## **Bath Clean Air Plan**

Bath and North East Somerset Council

### **Clean Air Zone Boundary Updates**

674726.BR.042.FBC-04 | 3

**Figure 2-4: First proposed extensions to the CAZ**

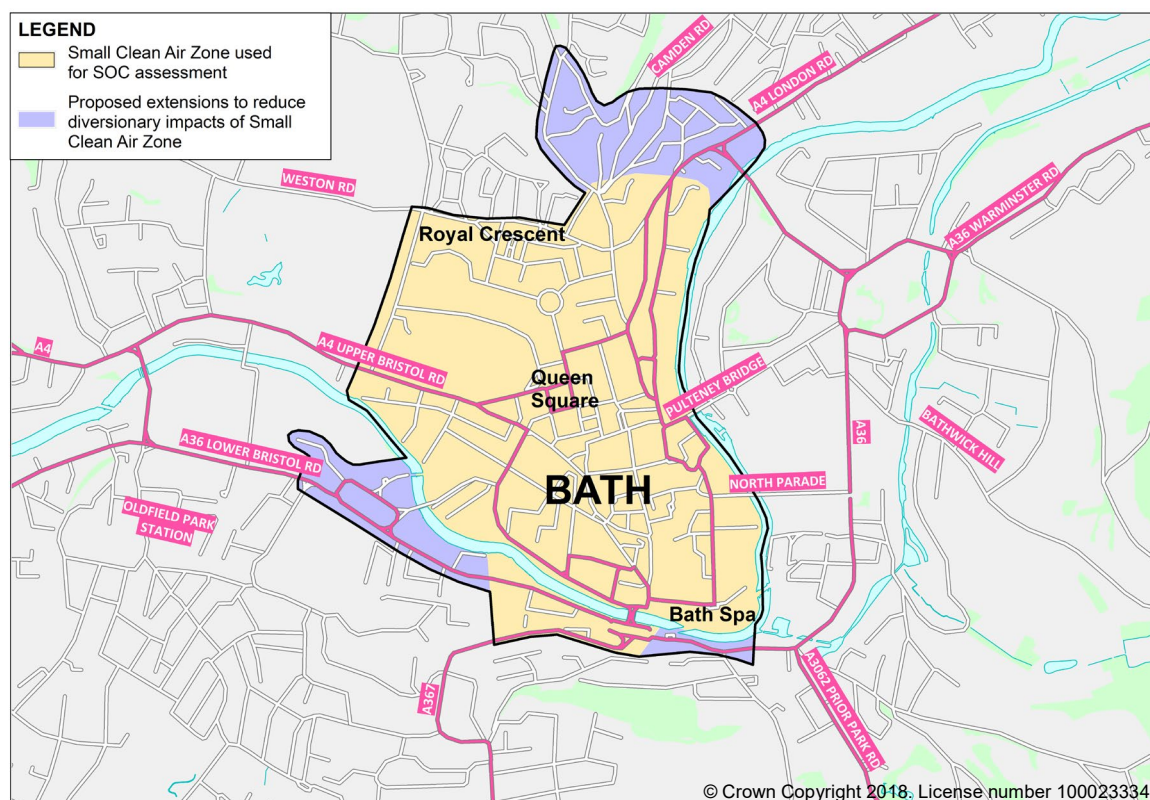
Following an initial assessment and ongoing discussions with key stakeholders within the Council, some amendments to the CAZ were proposed in April 2018. These are shown on **Figure 2-4** above in purple and described below:

- Northwards to St. Stephen's Church (Lansdown Road/Richmond Road junction). Eastwards through Camden Road, Gay's Hill, principally to include the A4 London Road/Cleveland Place junction;
- South East along the A36 Claverton Street to include the junctions with Lyncombe Hill and Widcombe Parade; and
- South West along the A36 Lower Bristol Road to include Pines Way gyratory and the Brougham Hayes junction.

These extensions were primarily focused on preventing the undesirable re-routing of non-compliant vehicle trips around the edges of the zone, which might otherwise result in worsened air quality in these areas and/or undesirable congestion issues.

**Figure 2-5: Second proposed extension to the CAZ**

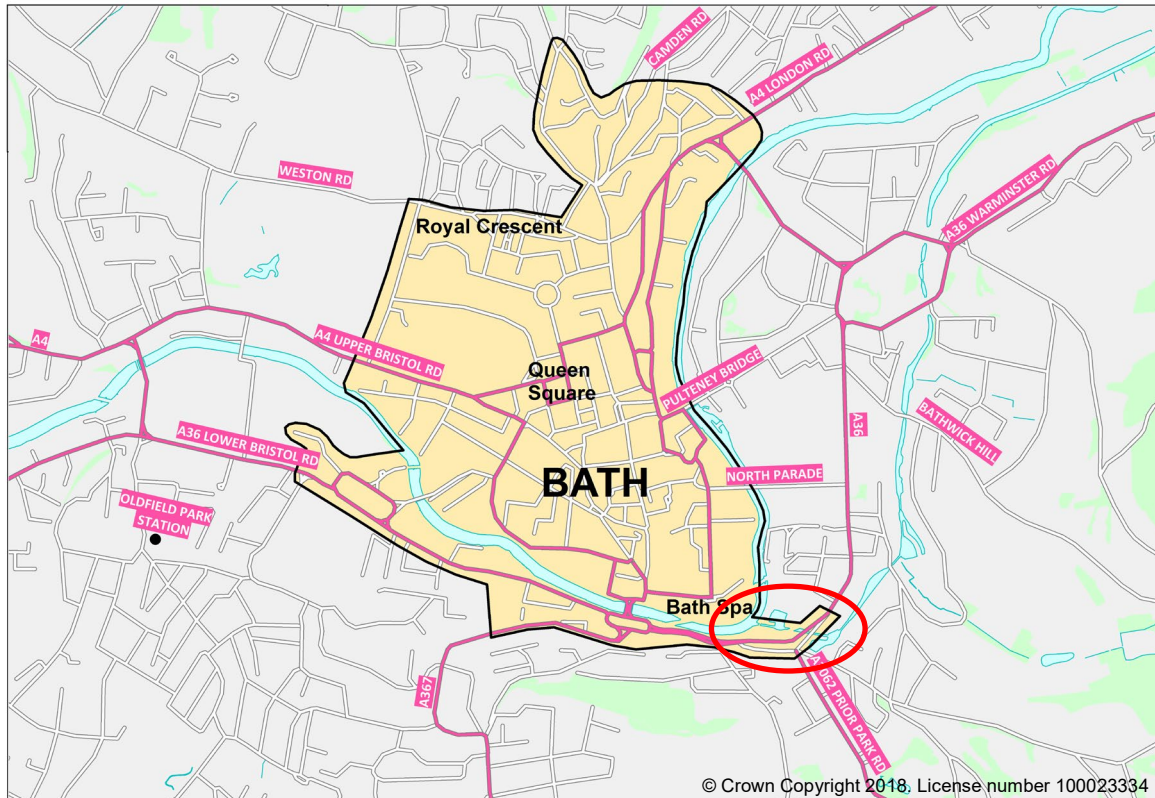
**Figure 2-5** shows a further extension, circled in red, which was made to the south east corner of the zone in May 2018. This was to extend coverage to include the A36 Rossiter Road and the gyratory system in Widcombe. The main objective was to include the White Hart junction at the bottom of Widcombe Hill and Prior Park Road, so preventing 'rat-running' or avoidance issues with routing of non-compliant vehicles between these roads and the A36 Pulteney Road. A further issue with not including the White Hart junction was the risk of increased traffic routing between the A36 Pulteney Road and Greenway Lane, using Prior Park Road, Rosemount Lane and Forefield Rise. The latter two roads are narrow residential streets where opportunity for two-way passage is very limited.

**Figure 2-6: Third proposed extension to the CAZ**

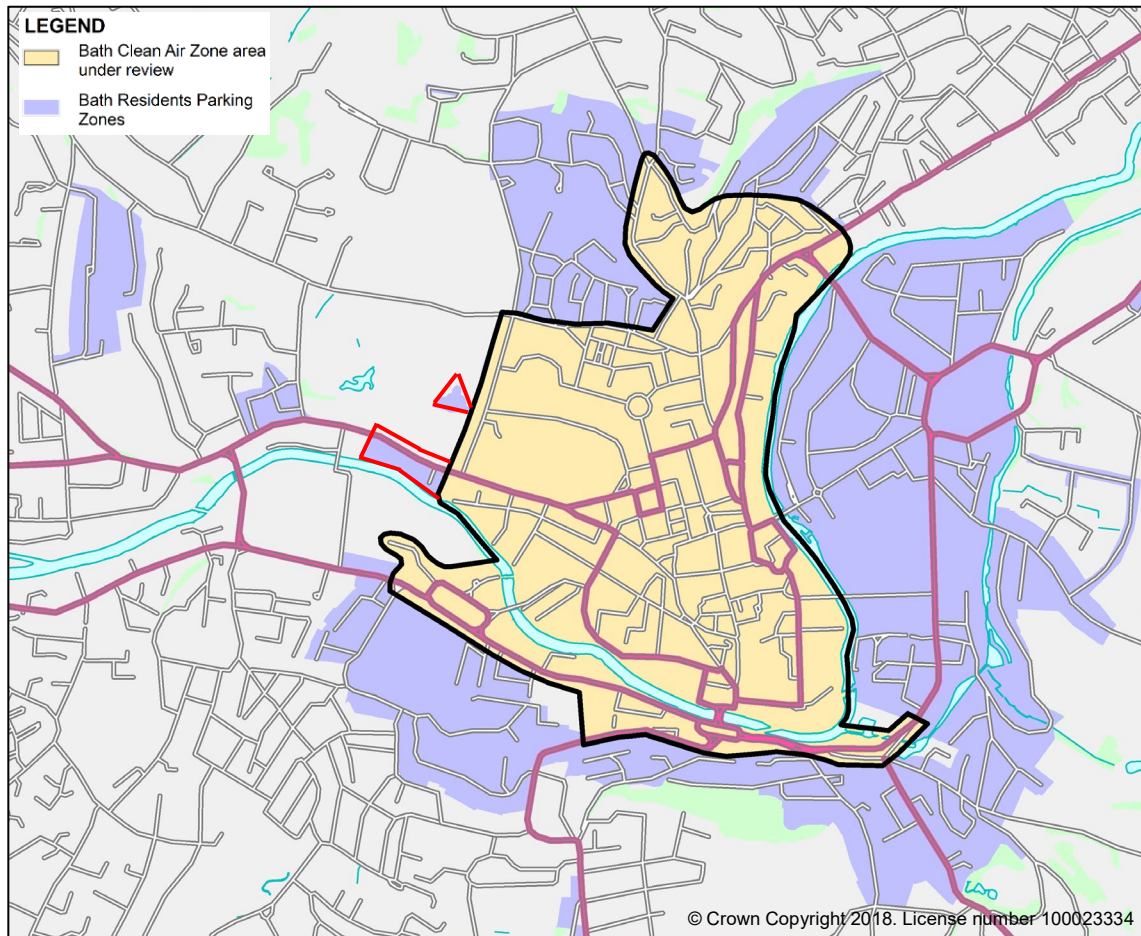
Minor changes to the boundary were again made in June 2018. These are shown by the red lines in **Figure 2-6** and ensure that the entirety of Residential Parking Zone (RPZ) 6 was within the CAZ boundary. It was considered that if a small part of RPZ 6 remained outside the zone boundary, it could result in parking here being more desirable to residents of RPZ 6, particularly if a large part of the vehicle ownership was non-compliant.

**Figure 2-7: Fourth proposed extensions to the CAZ**

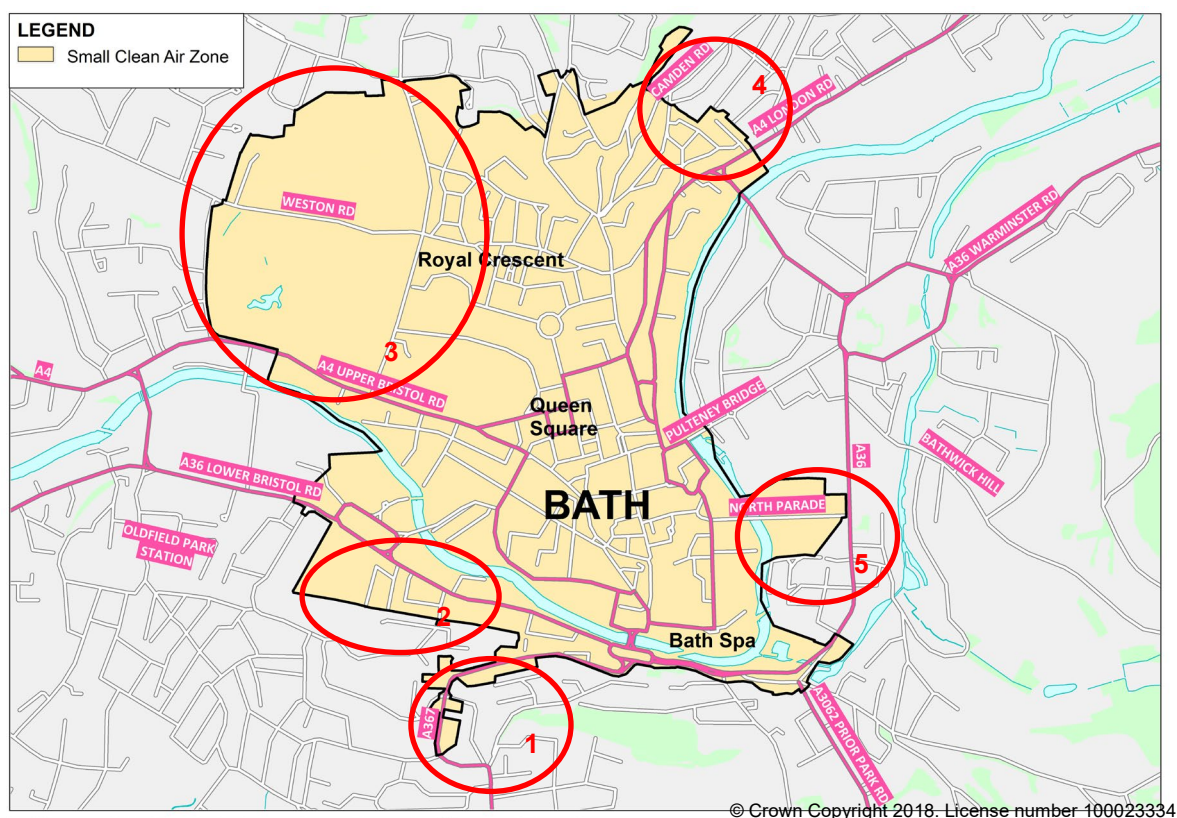
Following a meeting and a walk around the CAZ boundary with B&NES officers, several adjustments to its position and 'detailing' were made. The changes that were agreed upon are highlighted in the red circles and numbered in **Figure 2-7** above. They include the following:

- 1) An extension to the south up the Wells Road (A367) to the junction with Oldfield Road (B3111). This includes new boundary crossing or 'cordon' points on Hayesfield Park and Upper Oldfield Park, whilst the cordon point on the A367 is moved to a point just north of the B3111 Oldfield Road junction.

- This change was proposed by the residents of Upper Oldfield Park to avoid rat-running on what is a minor road, and one which serves as a main point of access to Hayesfield school. The signed position of the CAZ cordon point on the A367 just north of, or effectively at, the junction, means that drivers turning to avoid entry would do so via a 'B' classified road.

- 2) Moved to the south to the railway bridge on Westmoreland Road, with the revised cordon point just north of the junction with Westmoreland Station Road/Lower Oldfield Park/Thornbank Place.

- This change was made as the junction is a clearer and more obvious turn-around point before entering the CAZ. Even HGVs would have the opportunity to turn around here using the entrance area to Westmoreland Station where the carriageway area is quite wide. This change removed the need for two cordon points to/from the A36 Lower Bristol Road at Westmoreland Road and Cheltenham Street, the latter less than ideal;

- 3) Extended to the north west to encompass the entirety of Victoria Park, as well as the whole of the 'St. James Square' area. It was considered this was desirable because of a number of factors as follows.

- The boundary crossing point situated by the Victoria Monument in Victoria Park just west of Marlborough Lane was considered unlikely to be acceptable due to its proximity to the monument;

- The large number of medium-stay (up to 4 hours) parking spaces available in Victoria Park could become more popular if omitted from the zone. This could serve to increasing vehicular traffic in the

park. As the primary CAZ scheme objective is to promote clean air, it was considered that decreasing the quality of the air in a park would be counter intuitive; and

- The initial zone created a lot of boundary crossing points onto Julian Road, with signing/ANPR cameras needed to cover several minor roads. The revision to the boundary meant that this could be reduced and rationalised to only one cordon point at the top of Cavendish Road.

- 4) Small changes to the boundary crossing points on Camden Road and Gay's Hill and an extension to cover a large property on Rivers Road with access 'only' off St. Stephen's Road.

- The change to the boundary crossing points on Camden Road and Gay's Hill were done to make the cordon 'entry' points and signing more visible from the preceding junction, allowing drivers to use the junctions as decision points to avoid entering the zone should they choose; and

- The boundary was extended around the said property in Rivers Road due to its sole vehicular access via the junction with St. Stephen's Road, which was already inside the zone.

- 5) Adjusted east to the end of North Parade Road.
- This eastward movement of the boundary crossing point on North Parade Road to the junction with the A36 Pulteney Road was proposed to avoid 'entrapment' of drivers making the turn into North Parade. This is because, once such turns are executed, there was considered to be no viable means of a non-compliant vehicle taking action to avoid zone entry. Whilst turning within the Sports Centre or Cricket Ground car parks would be possible to execute a 'U' turn, this was hardly considered ideal.

**Figure 2-8: Fifth proposed extensions to the CAZ**

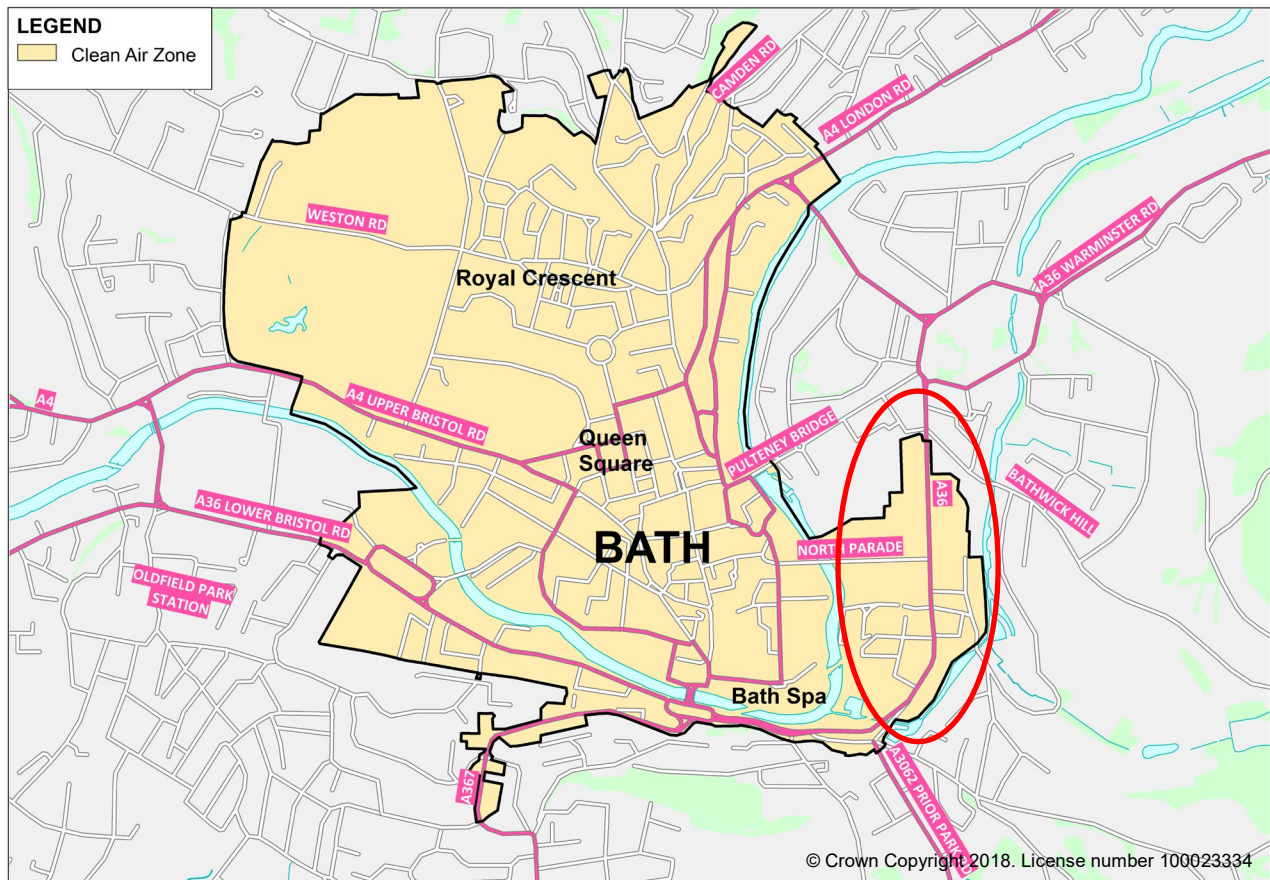
Following a meeting with cabinet the CAZ was further extended in the Widcombe area, as circled in red on **Figure 2-8** above.

The CAZ boundary has been extended to capture the entirety of the A36 Pulteney Road, Pulteney Gardens, The Bath Hotel and Widcombe C of E primary school. The boundary line now cutting off at the Bathwick Hill Roundabout to the north and following the canal to the east. This has resulted in the moving of two boundary crossing points in the area; one from the east end of North Parade to the southbound A36 exit from Bathwick Hill Roundabout, and the other from Pulteney Road to where Pulteney Gardens crosses the canal.

The reason behind the boundary extension was the potential for 'entrapment' and vehicle avoidance impacts on the now included residential streets. A 'key' issue was the likely impact on Widcombe C of E Primary School, with minor streets around the school offering the most obvious turning around or 'U' turn opportunity for a non-compliant vehicle driver when approaching the original cordon point just north of the Bath Hotel junction. An HGV reaching this point would have no real alternative to crossing the CAZ boundary. The new boundary addresses this operational risk by moving the cordon point on the southbound A36 to the exit point from Bathwick Roundabout. This would allow drivers seeking to avoid entry (including HGV drivers) to use either Bathwick Hill, Vane Street, or make a 'U' turn at the roundabout back to Sydney Place.

**Figure 2-9: Sixth proposed amendments to the CAZ**

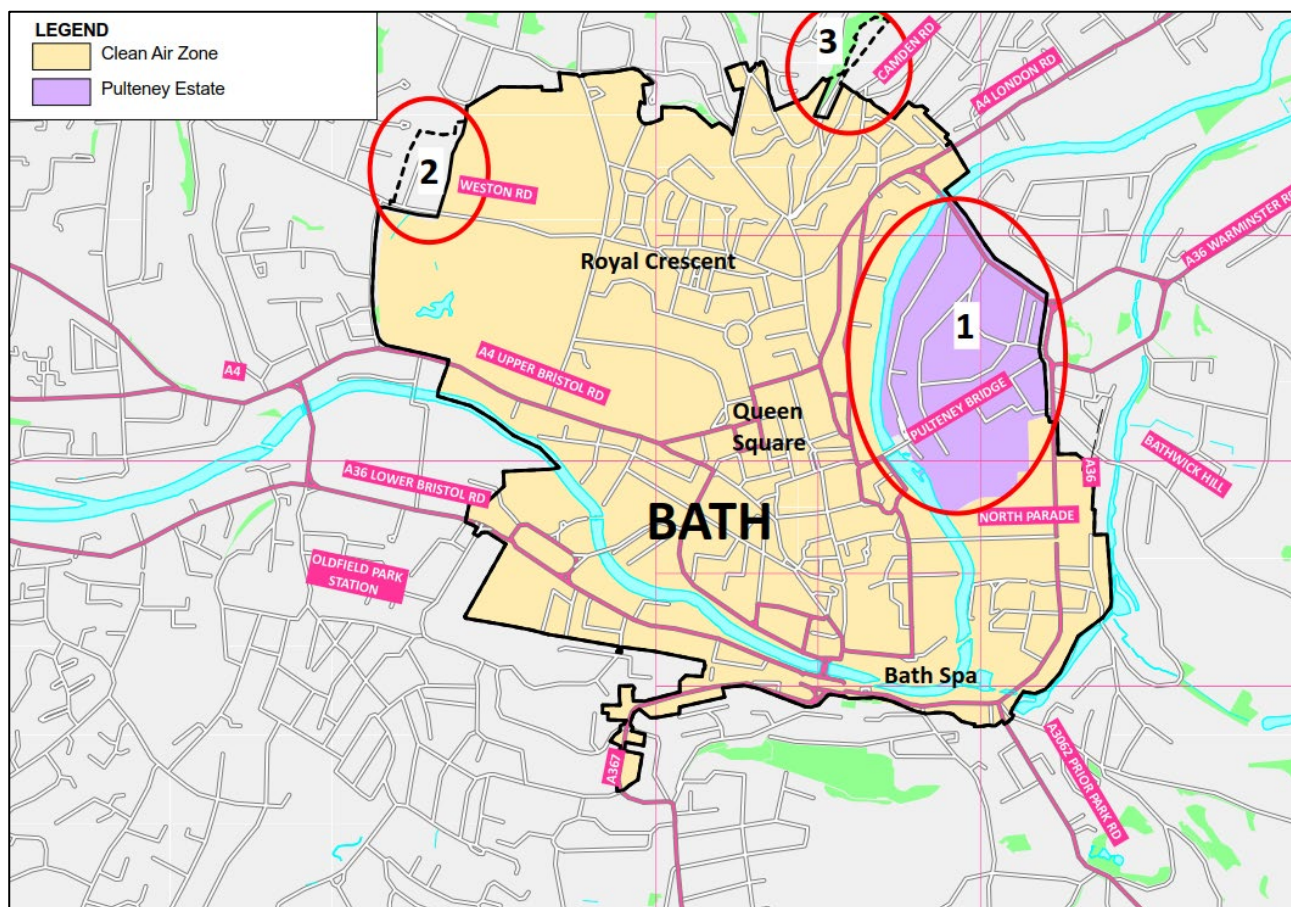
Following the consultation period, three alterations to the CAZ boundary were proposed, with a new area being included and two areas being removed. These are shown in **Figure 2-9** above and described below:

- 1) Inclusion of the Pulteney Estate including Bathwick Street but excluding the A36 around Sydney Gardens.
  - During the consultation period there were concerns from residents in the Pulteney and Bathwick Estate about an increase in idling coaches, rat-running traffic and drop-offs or parking of non-compliant vehicles in the area, as it was very close to the city centre.

- Including this area only and leaving the A36 outside the zone, allows for suitable 'turn-back' options for large vehicles via the Sydney Gardens 'loop' (Beckford Road/Sydney Place/Sydney Road) or a 'U' turn at Bathwick Roundabout. If the A36 to the North Road junction had been included in the zone, large vehicles could become entrapped as they would have no option to avoid entering the CAZ. Light vehicle traffic may also have increased on North Road, outside of King Edwards School.

- 2) Removal of Cranhill Road to the west of the zone.
  - During the consultation, several people requested the removal on Cranhill Road from the zone as it was a cul-de-sac and therefore, not subject to much traffic. Cranhill Nursing Home would also be inside the zone, causing issue with carers, visitors and deliveries. Removing the nursing home would alleviate these issues.

- Removing Cranhill Road increases the risk that vehicles may turn around in it to avoid the CAZ, however, this is considered low risk.
- 3) Removal of Rivers Road and Beacon Wood House from the north part of the zone.

- Rivers Road is a private road which leads only to a Beacons Wood House, a private property which also has access from Perfect View and, therefore, doesn't need to be inside the zone.
